4/23/03	Revised 6'x4' Culvert Extension Per Change Order
DATE	REVISION
STATE OF HAWAII DEPARTMENT OF TRANSPORTATION HIGHWAYS DIVISION DRAINAGE PLAN - 1 KAMEHAMEHA HIGHWAY RESURFACING Waiahole Valley Road to Crouching Lion Inn Federal Aid Project No. NH-083-1(43)	
Scale: 1" = 10'	Date: August 1, 2000
SHEET No. C-27 OF 65 SHEETS

KAMEHAMEHA HIGHWAY RESURFACING
Waiahole Valley Road to Crouching Lion Inn
Federal Aid Project No. NH-083-1(43)

FED. ROAD DIST. NO.	STATE	FED. AID PROJ. NO.	FISCAL YEAR	SHEET NO.	TOTAL SHEETS
HAWAII	HAW.	NH-083-1(43)	2001	C.O.34S-1	121

TYPE 201214P STEEL FRAME AND GRATES

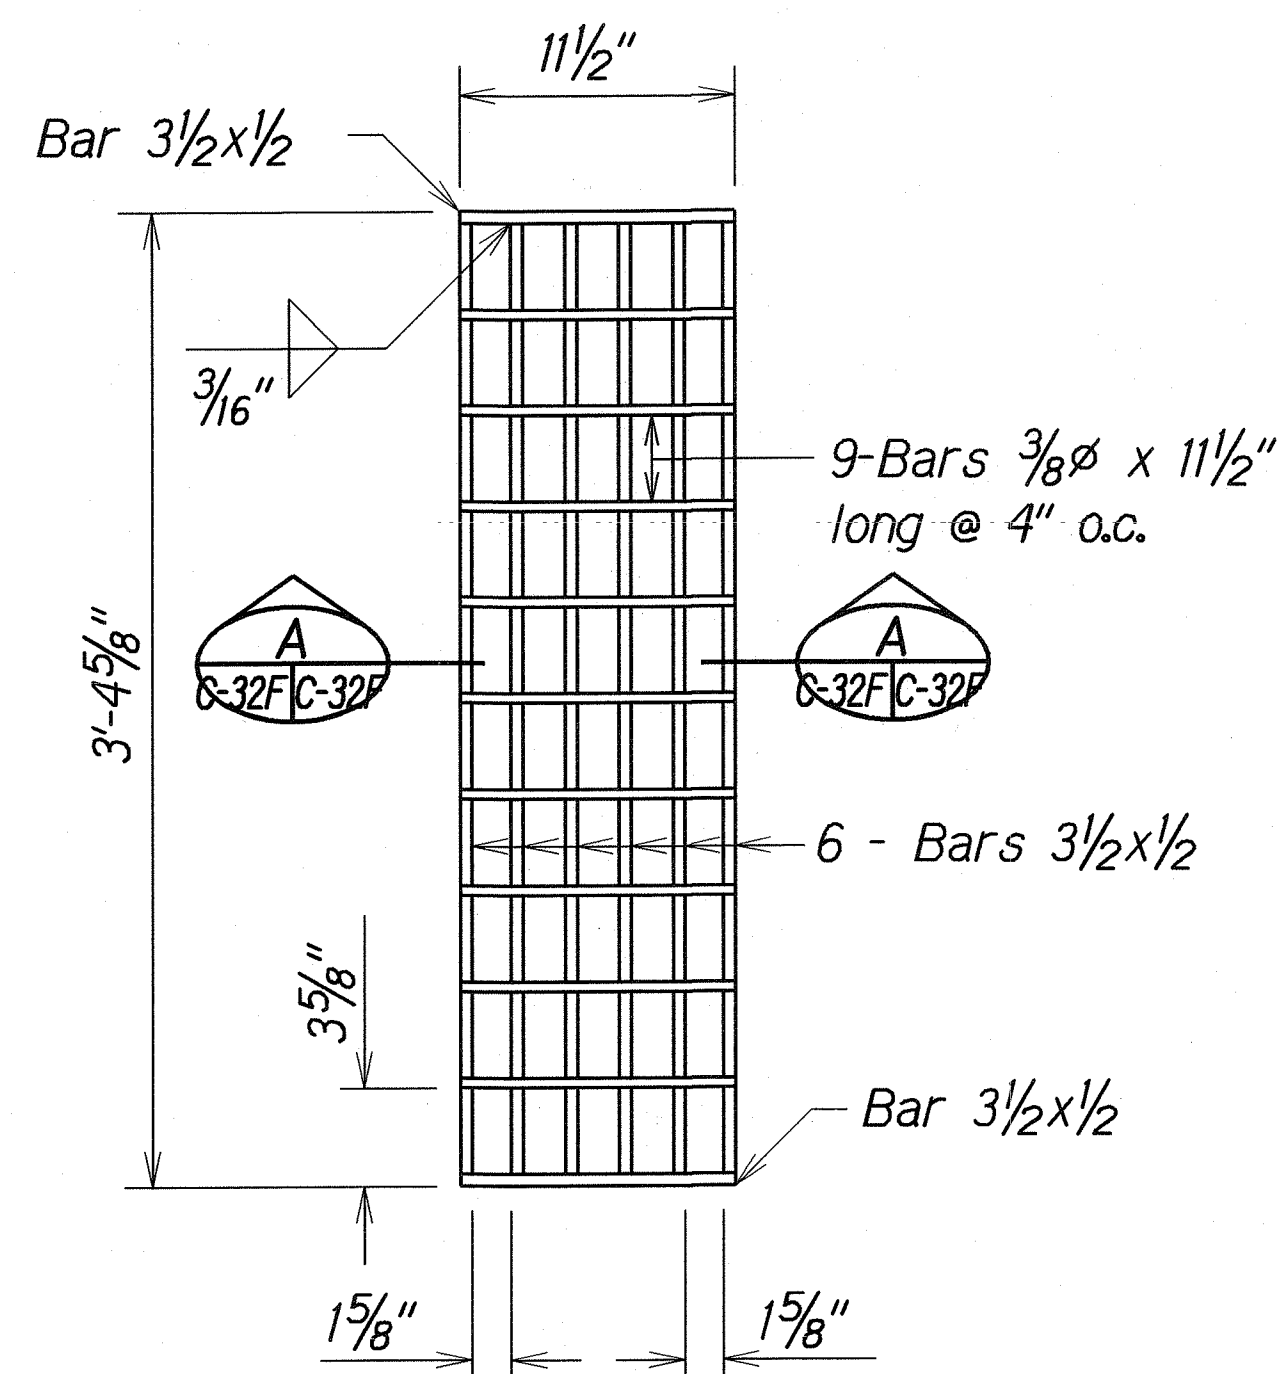
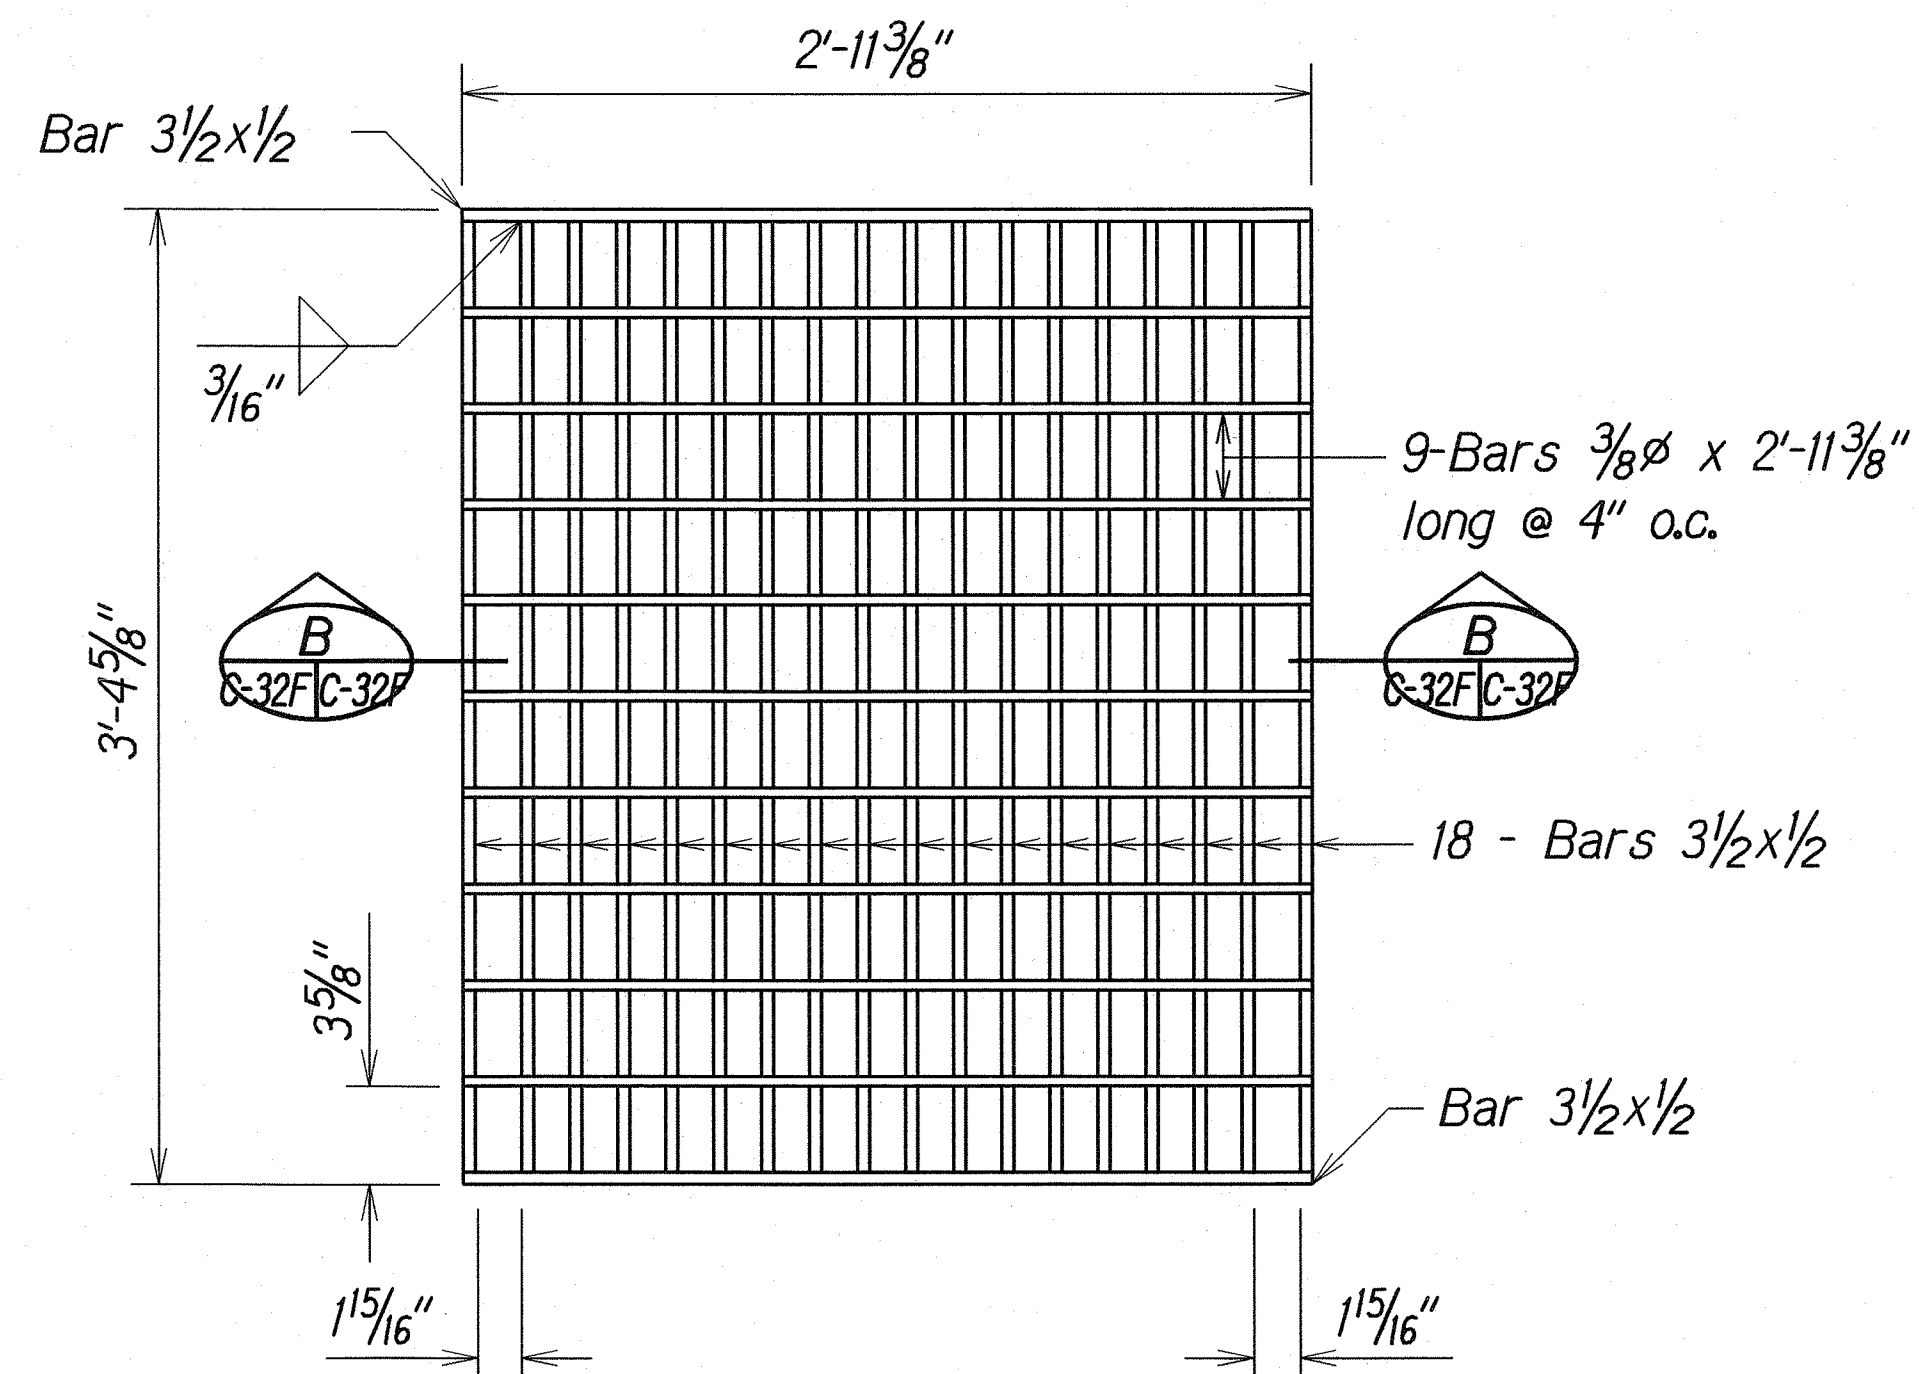
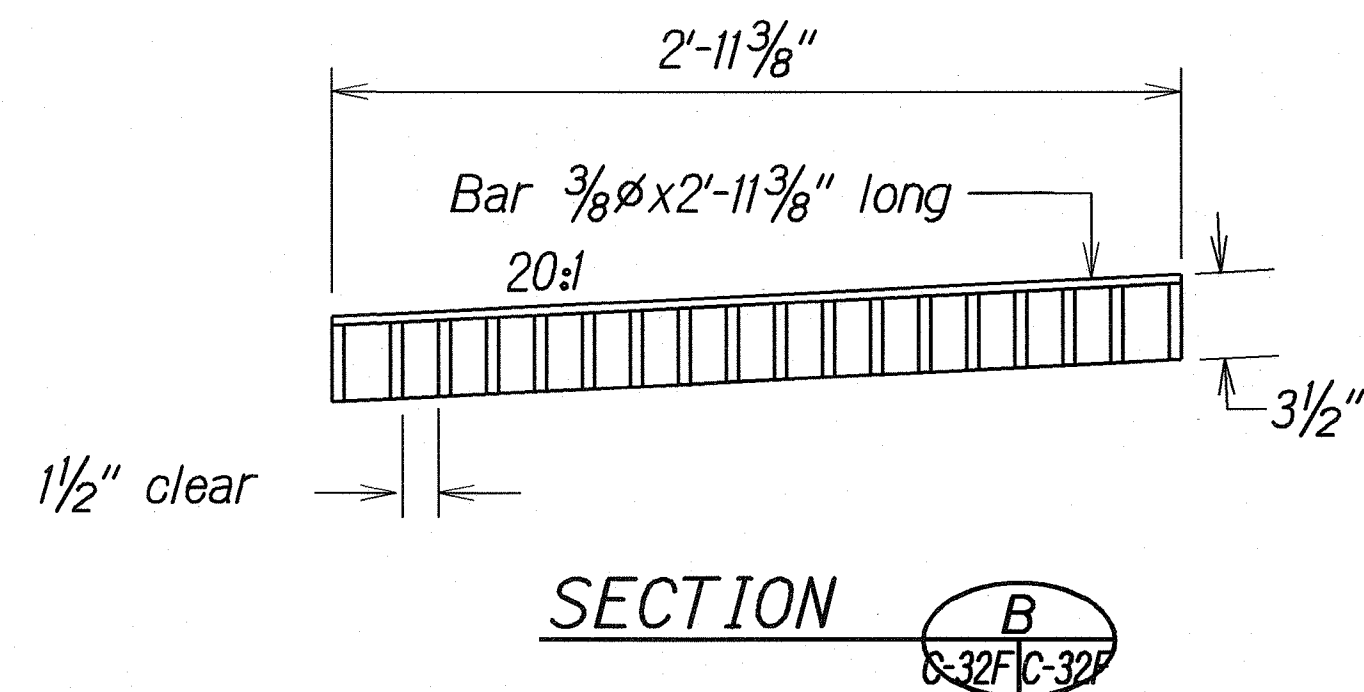
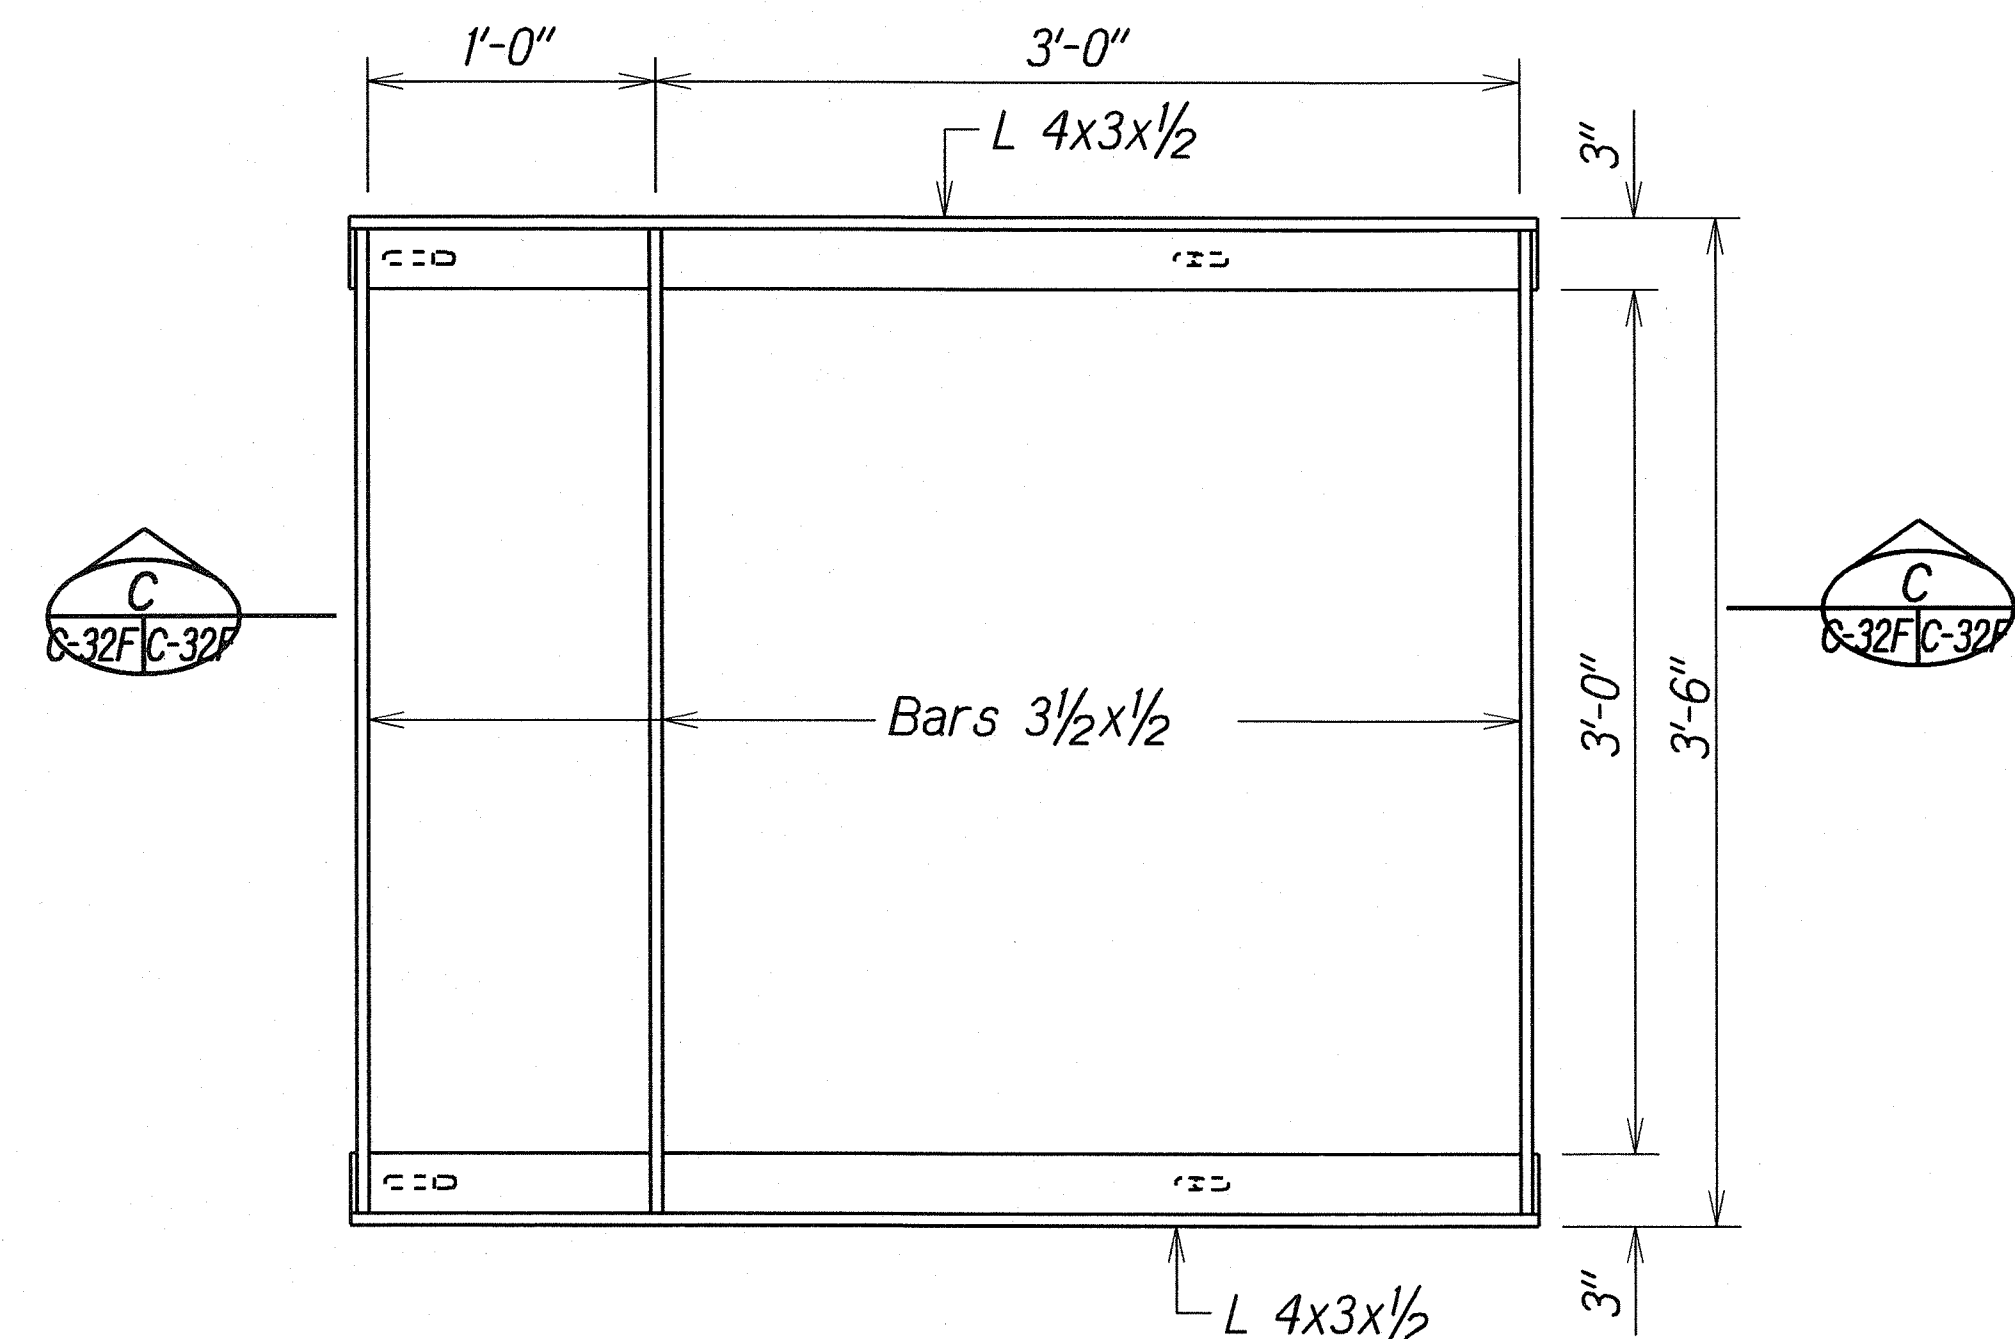
9/3/02	Add drainage detail of Type 201214P Frame and Grates.
DATE	REVISION
STATE OF HAWAII DEPARTMENT OF TRANSPORTATION HIGHWAYS DIVISION	
DRAINAGE DETAILS	
KAMEHAMEHA HIGHWAY RESURFACING Waiahole Valley Road to Crouching Lion Inn Federal Aid Project No. NH-083-1(43)	
Scale: As Shown	Date: April 2002
SHEET No.C-32F OF 74 SHEETS
